STANDARD DEPARTURE CHART-INSTRUMENT

RJFN / NYUTABARU

NIPPO SEVEN DEPARTURE

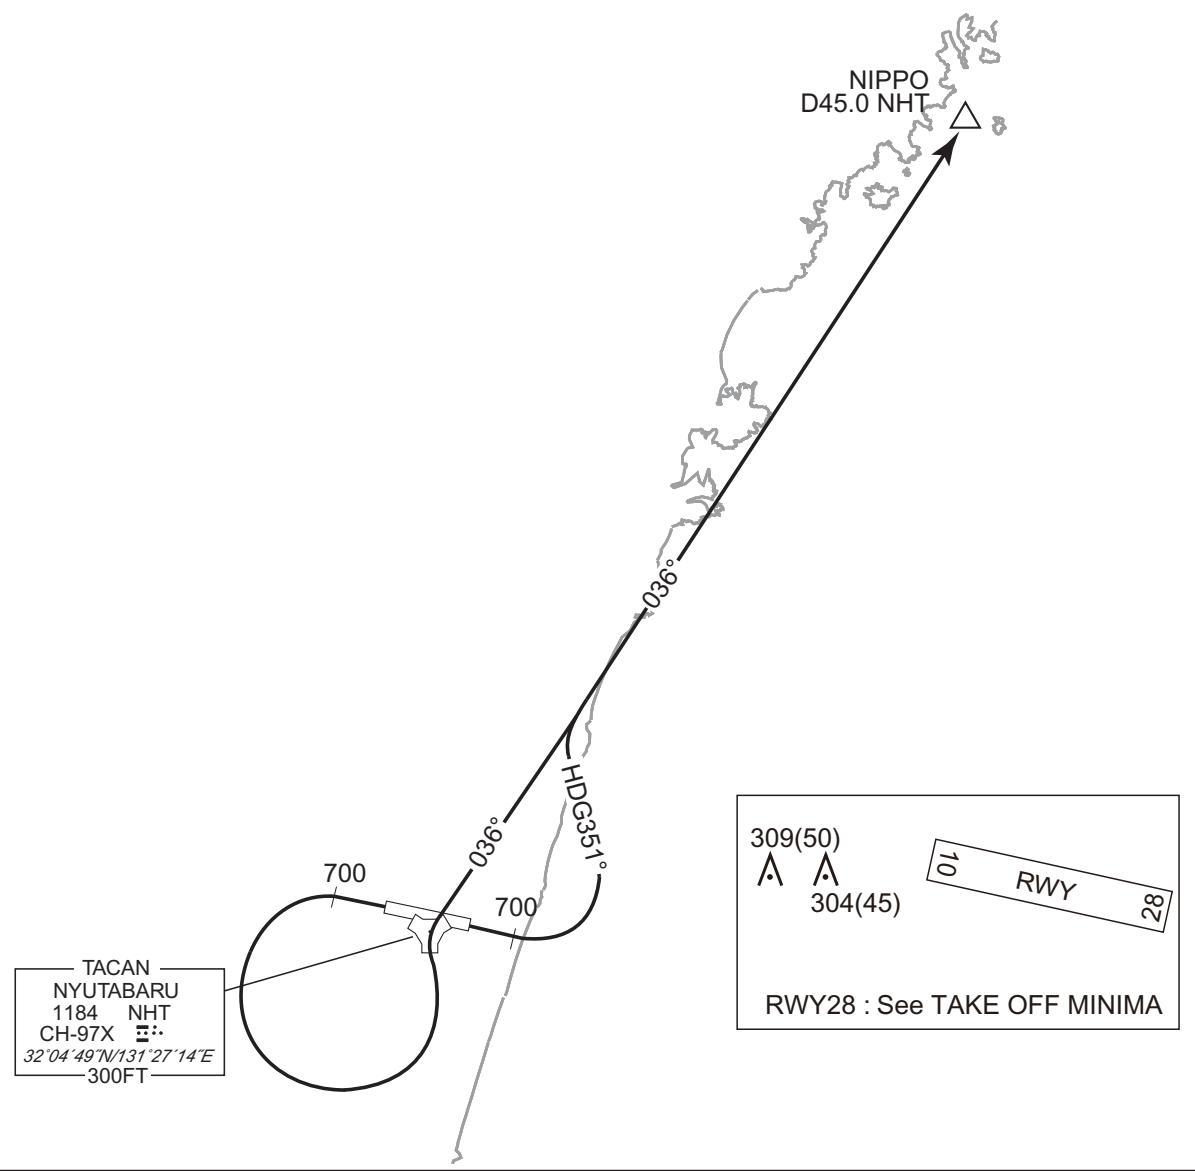
CHANGE : PROC renamed(NIPPO SEVEN DEPARTURE). PROC course(NIPPO SEVEN DEPARTURE). YATOGI TWO DEPARTURE abolished.
Restriction. Note, OBST added.

TENSO FOUR DEPARTURE

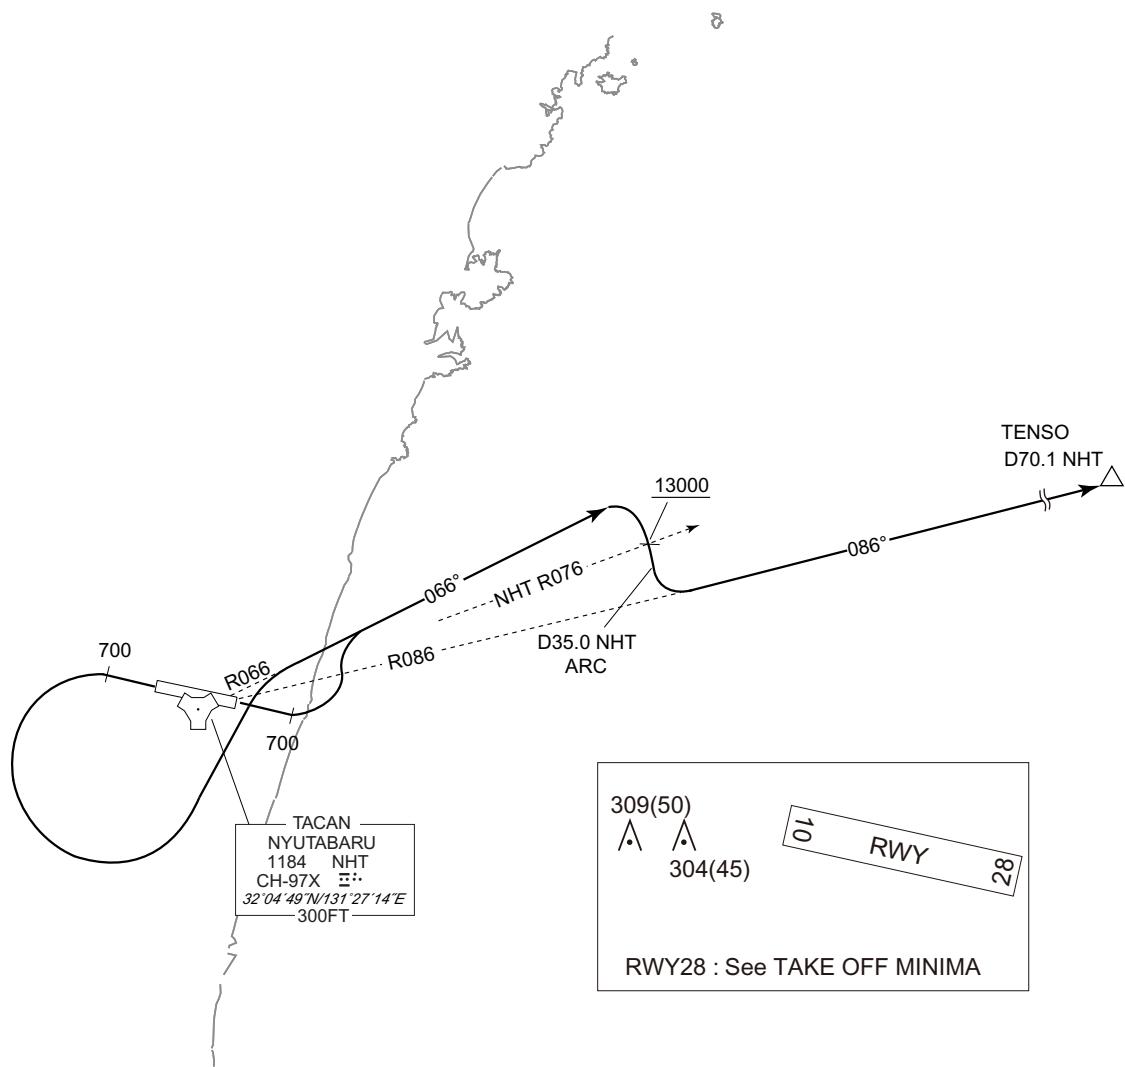
CHANGE : PROC renamed. PROC course. Restriction. Note, OBST added.

SAITO ONE DEPARTURE

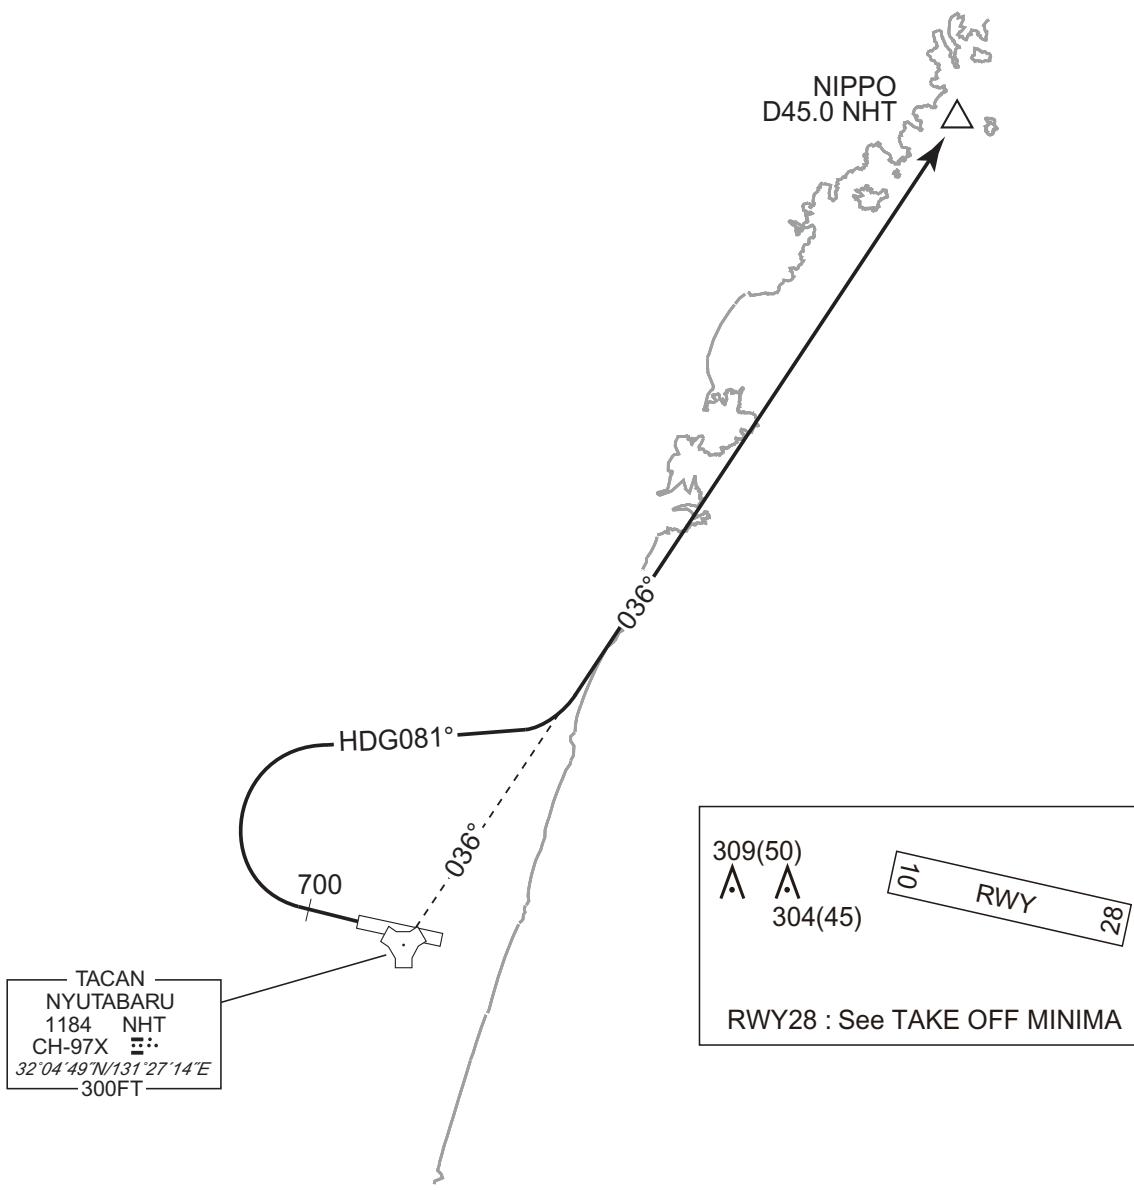
CHANGE : New PROC.

TRANSITION

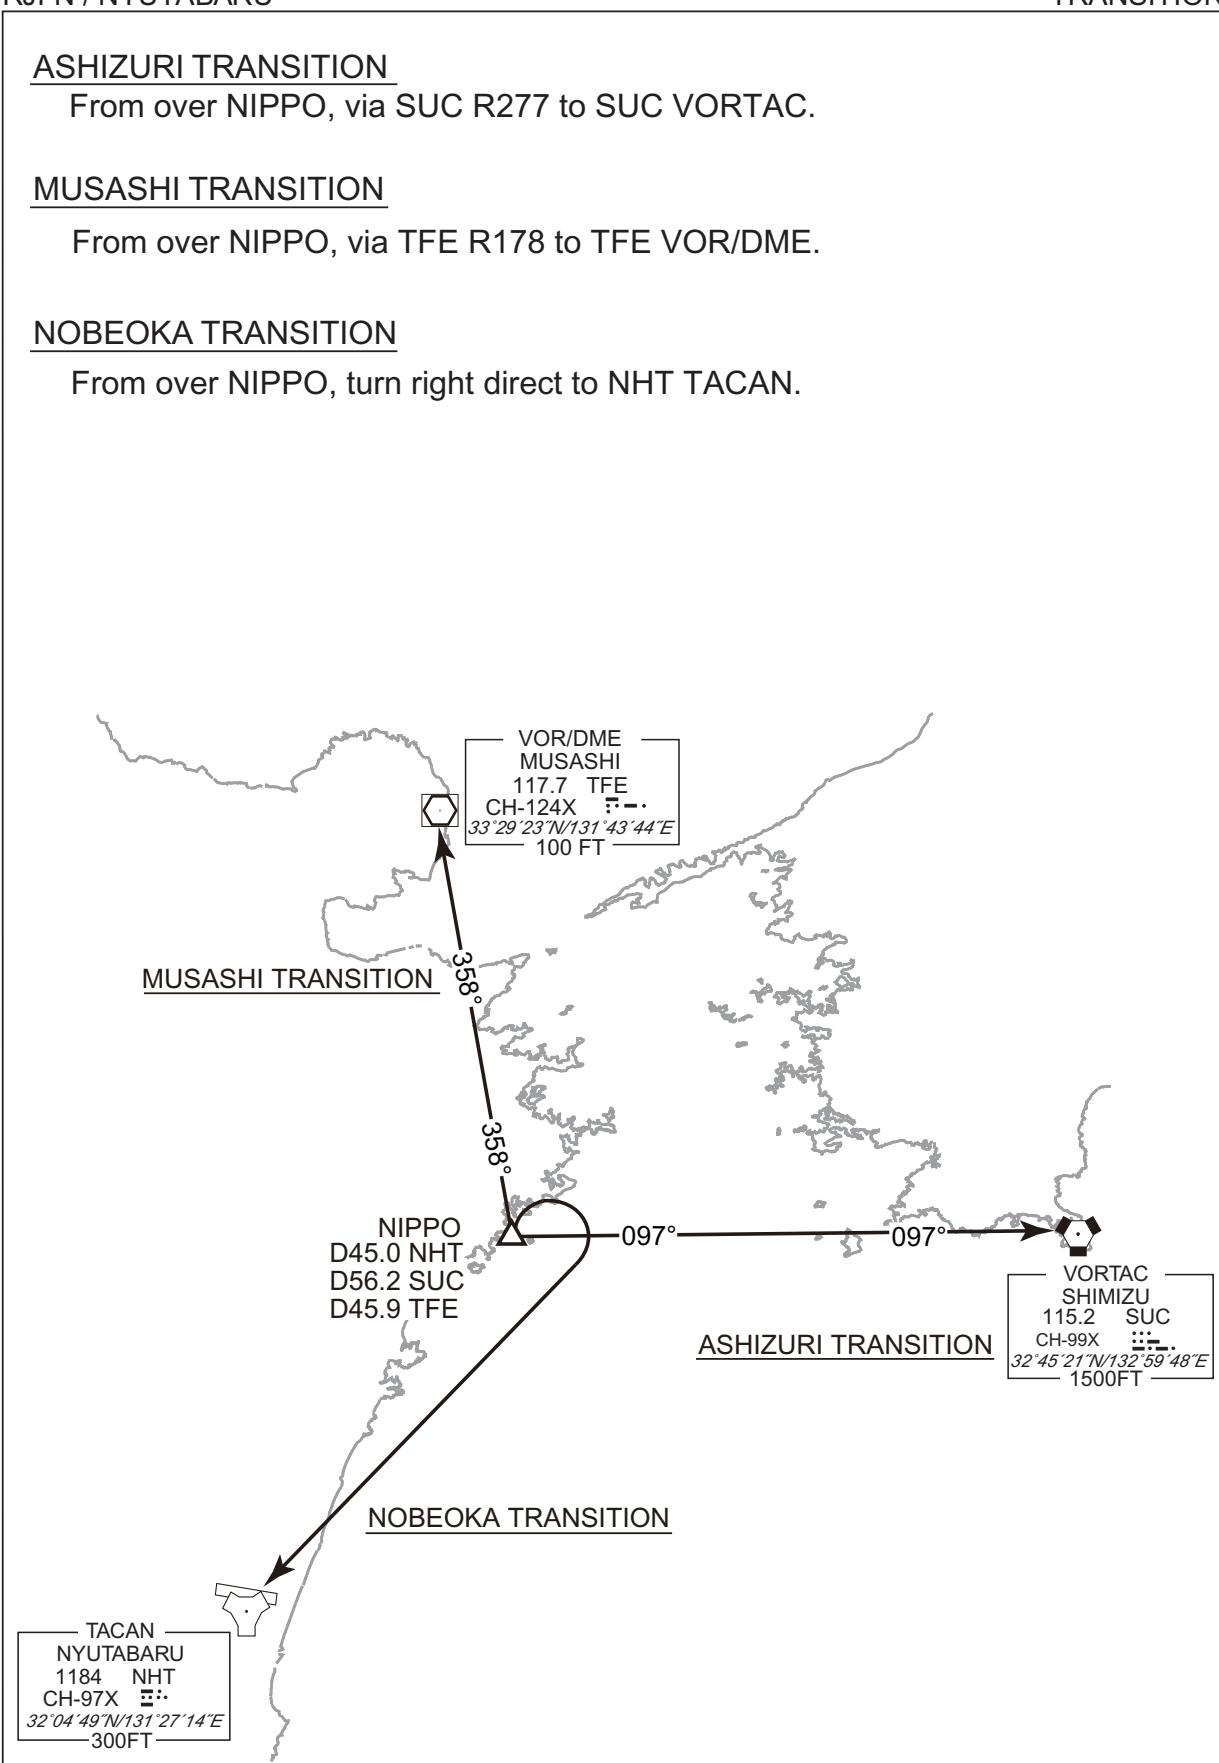
CHANGE : PROC course(NOBEOKA TRANSITION). Description of ASHIZURI TRANSITION, MUSASHI TRANSITION. ALT restriction.
SOBO TRANSITION abolished.

TENSO ARRIVAL

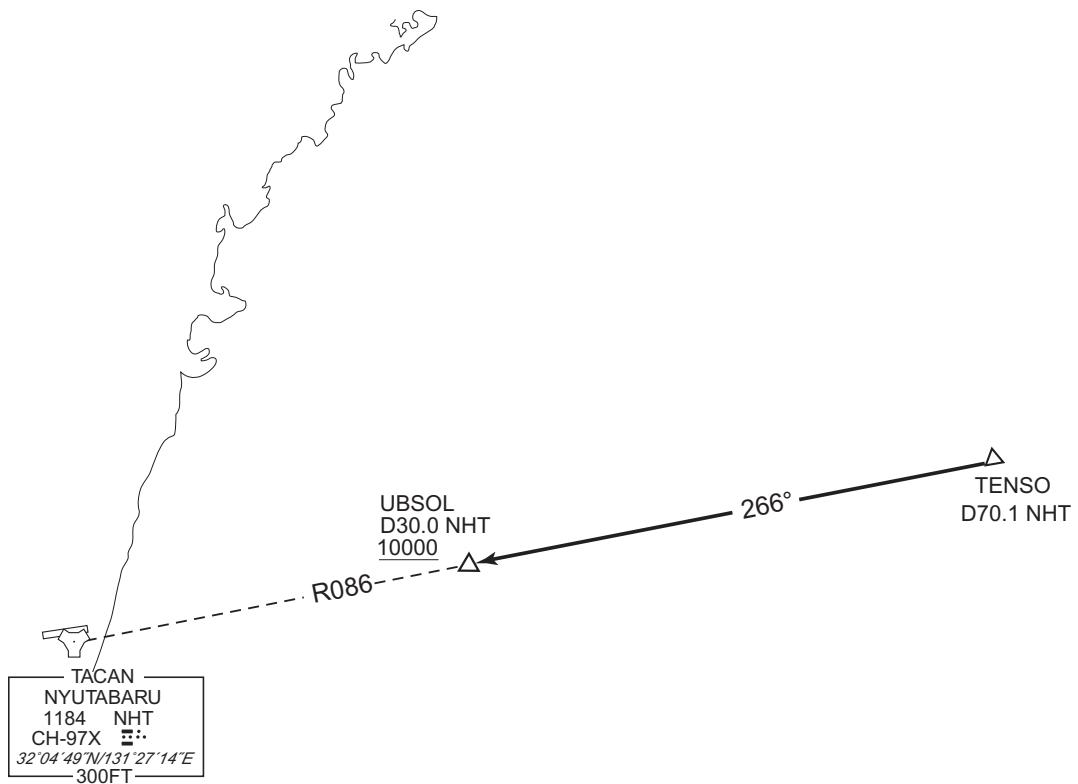
CHANGE : PROC course. UBSOL established. ALT restriction.

INSTRUMENT APPROACH CHART

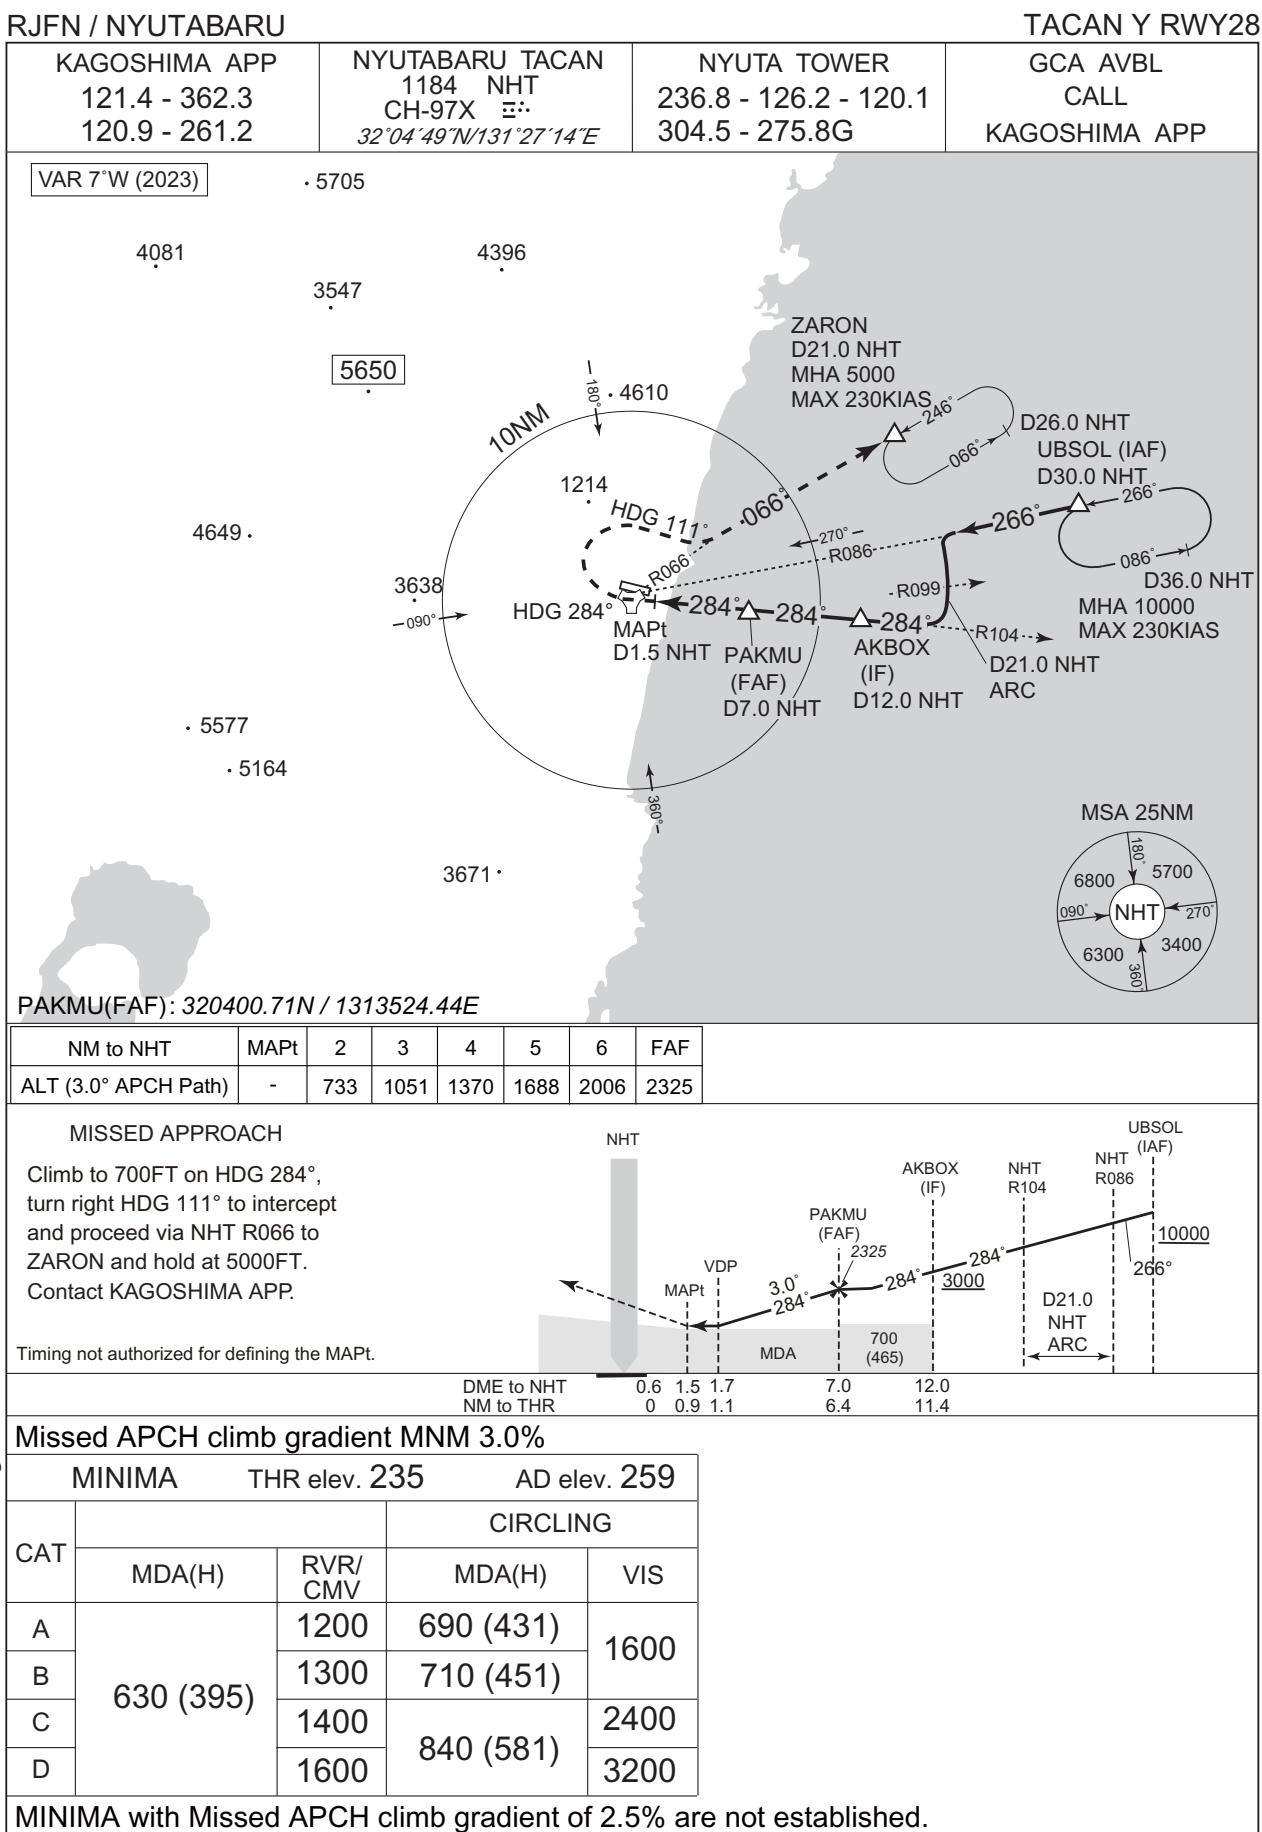
CHANGE : PROC course. Missed APCH course. MINIMA. UBSOL, PAKMU added. VAR. Missed APCH climb gradient MNM added. VAR.

INSTRUMENT APPROACH CHART

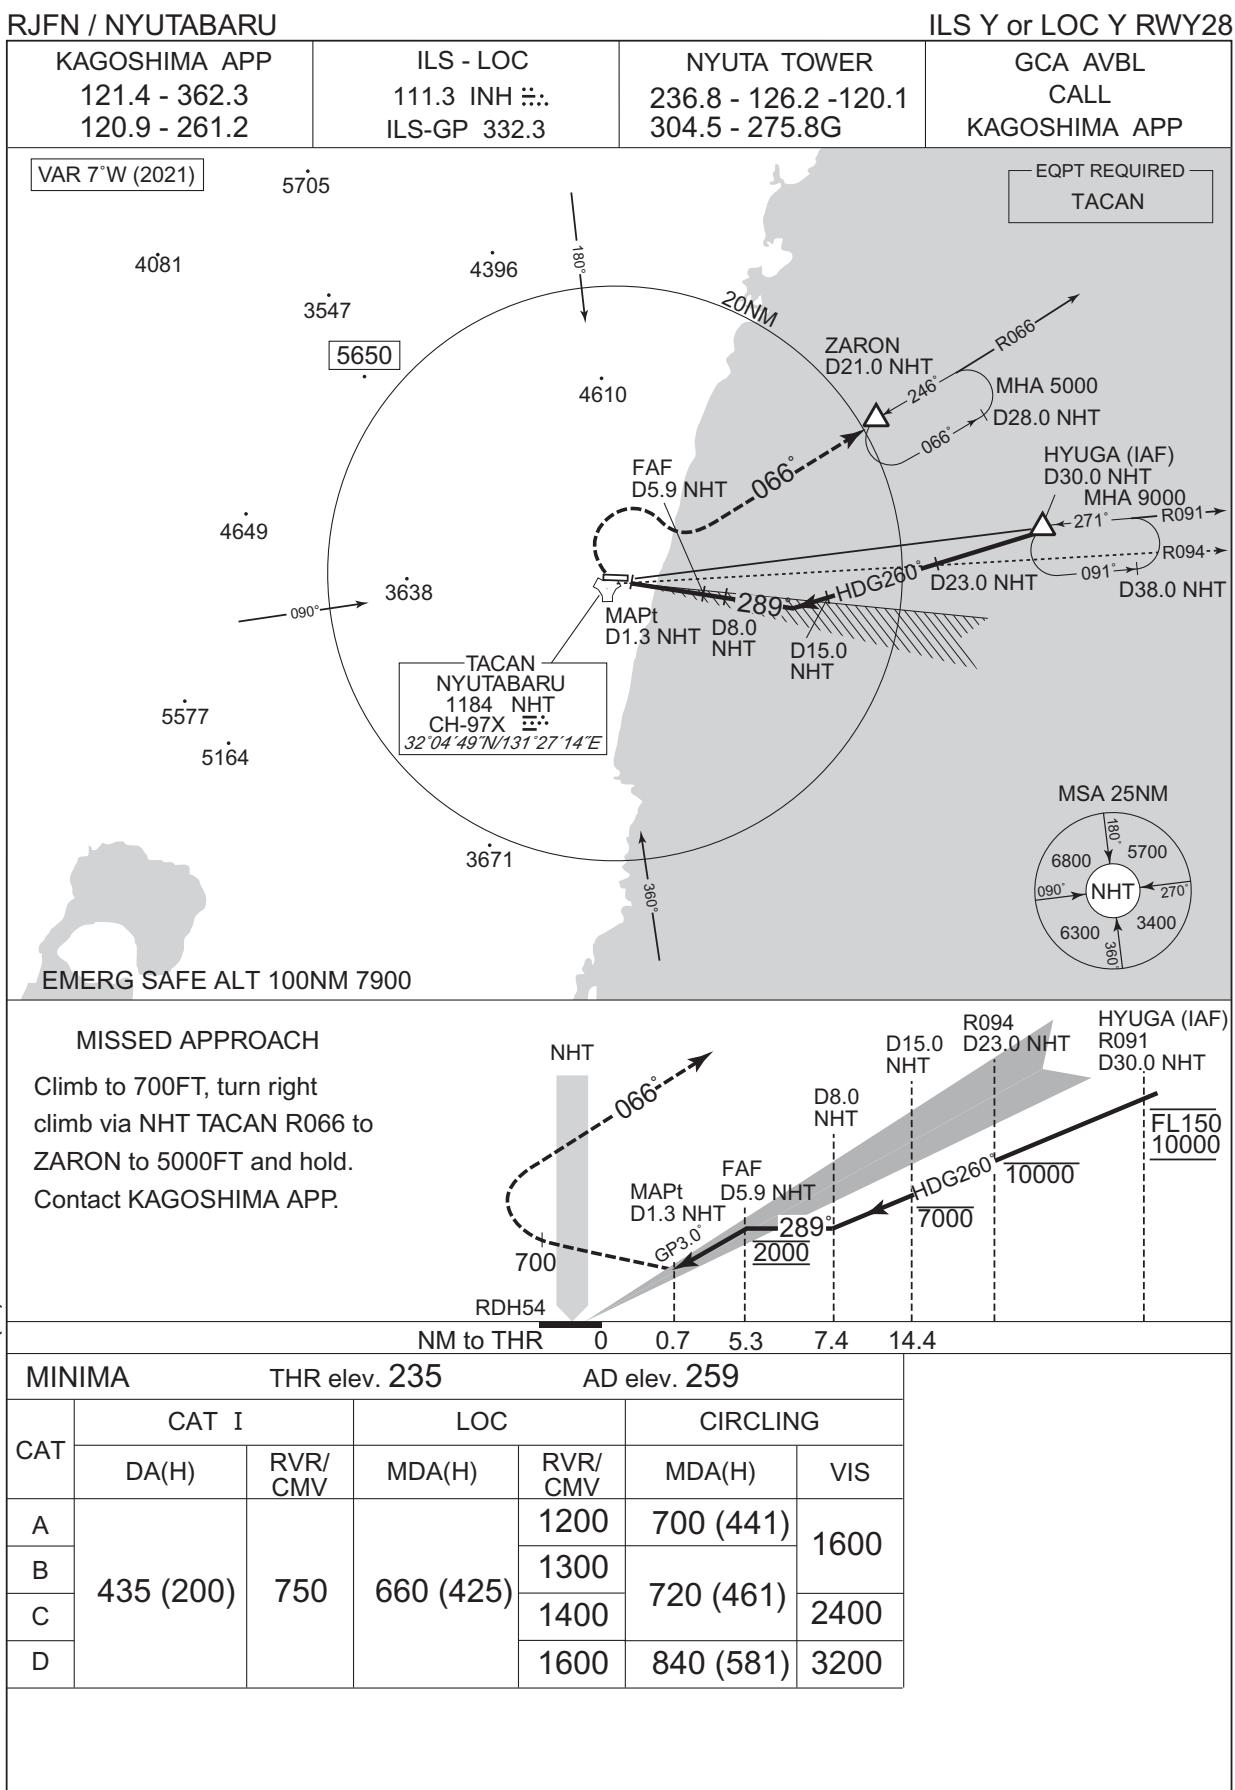
CHANGE : VAR, PROC renamed. EQPT REQUIRED added. PROC course. MISSED APPROACH course. MSA.
NM to THR added. MDA(H) for CIRCLING.
